SERVICE LETTER NUMBER 158

TITLE: AIR TRACTOR SHORT FINLET INSPECTION AND SUPPORT

BY: J. KAPSNER	AIRCRAFT MAKE/MODEL(S):	FLOAT MODEL(S):	NOTE(S):
APP: C. WOKEN	AT802A	10000A	Mandatory Compliance
DATE: 12/30/14			S/L P/N 1008241
REV: B			ECO 23774

Figure 1: Support Strut Installation (Upper Right Finlet Shown – View Looking Inboard)

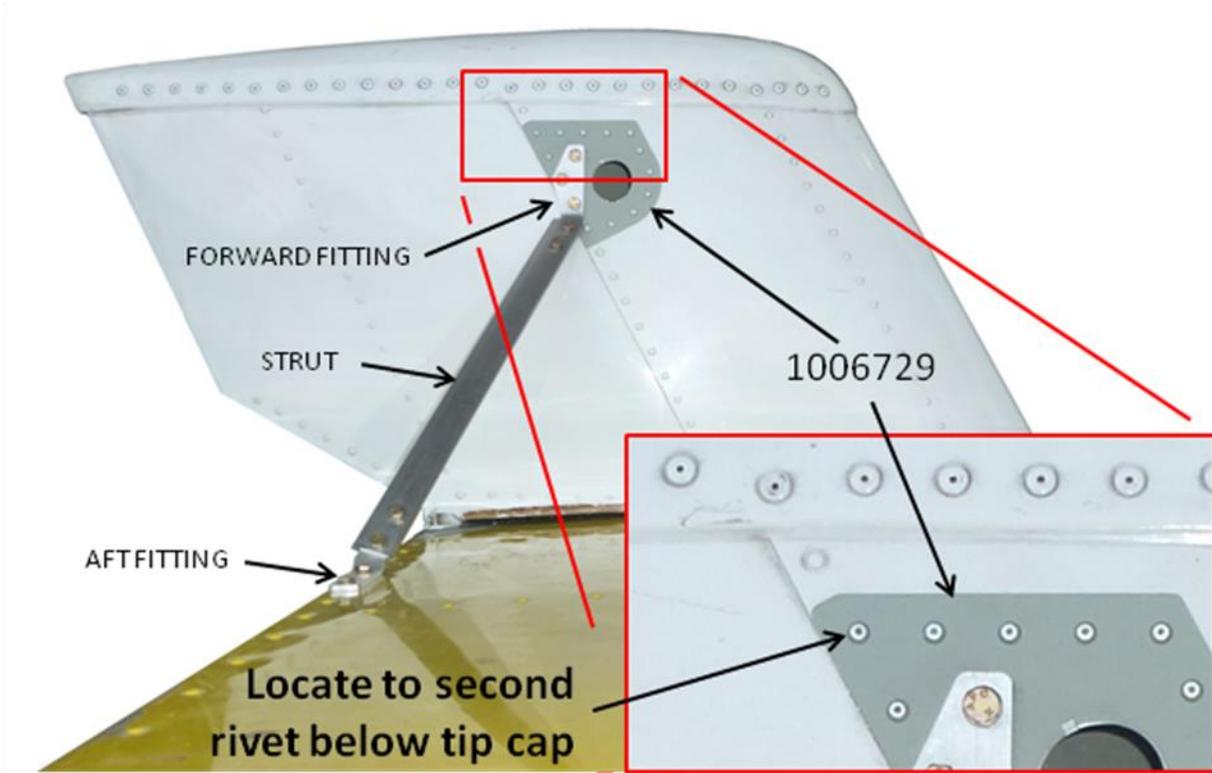
1. Perform the following service procedures after first securing airplane.
2. Position Doubler 1006729 on outboard side of Finlet as shown in Figure 1. Locate and drill out (5) existing rivets.

1. Perform the following service procedures after first securing airplane.
2. Position Doubler 1006729 on outboard side of Finlet as shown in Figure 1. Locate and drill out (5) existing rivets.

Figure 2: Aft Fitting Location (Upper Right Finlet Shown - Elevator Removed)

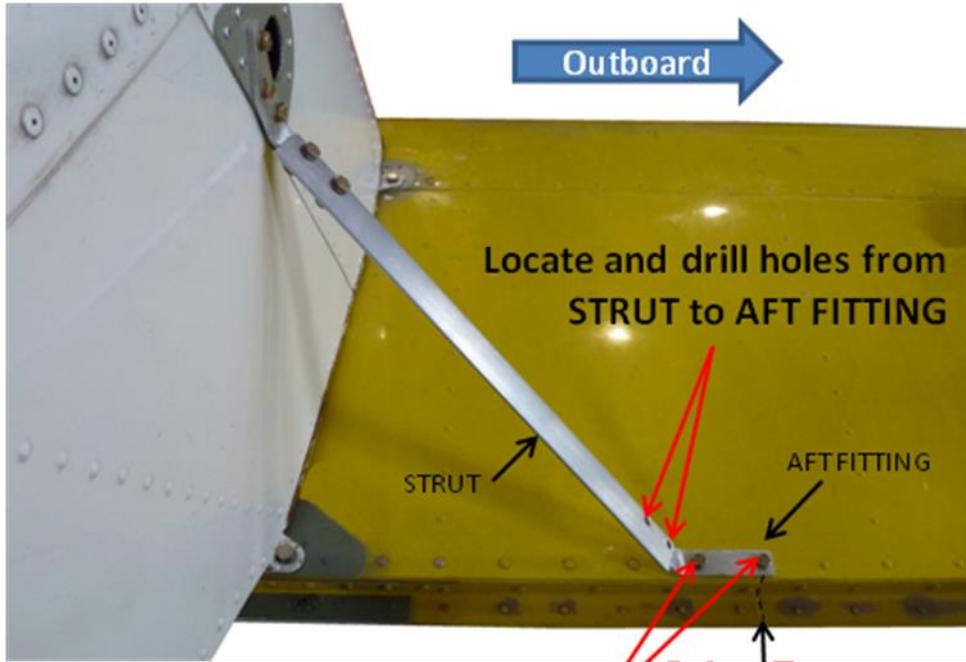
7. Locate and drill out (2) existing rivets in horizontal tail plane near elevator as shown in Figure 2.
8. Open up the (2) rivet holes in Horizontal Tail Plane to Ø.193"

9. Deburr holes
10. Install the Forward Fitting 1008231/1008232 and loosely attach Strut 1008235. Insert blank end of Aft Fitting 1008233/1008234 into Strut, and attach Aft Fitting to horizontal tail (Figure 2).

7. Locate and drill out (2) existing rivets in horizontal tail plane near elevator as shown in Figure 2.
8. Open up the (2) rivet holes in Horizontal Tail Plane to Ø.193"

9. Deburr holes
10. Install the Forward Fitting 1008237/1008238 and loosely attach Strut 1008236. Insert blank end of Aft Fitting 1008239/1008240 into Strut, and attach Aft Fitting to horizontal tail (Figure 2).

Locate common to last two rivets in rear spar doubler

End of rear spar doubler

Figure 3: Optional Support Strut Assembly - Exploded View (Upr-Lt/Lwr-Rt configuration shown)

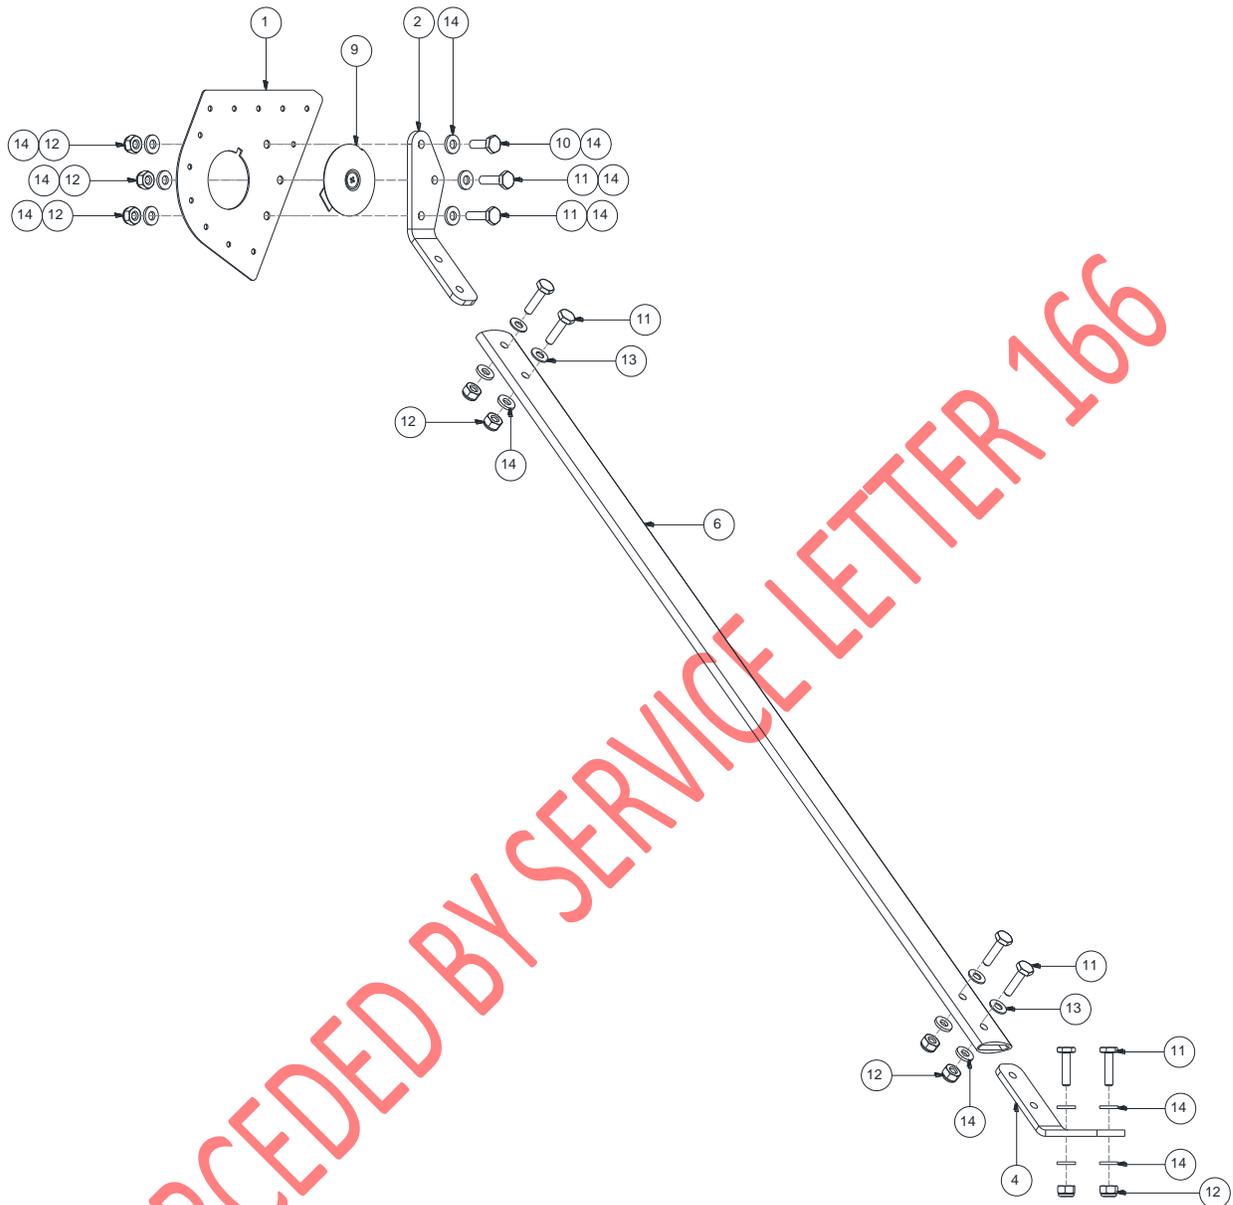
11. Match drill two holes from the strut into the lower fitting. (Recommend marking the lower fitting, then disassembling and drilling on bench.)
12. Install and tighten all strut hardware as shown in Figure 3 and coat with grease.

11. Match drill two holes from the strut into the lower fitting. (Recommend marking the lower fitting, then disassembling and drilling on bench.)
12. Install and tighten all strut hardware as shown in Figure 3 and coat with grease.
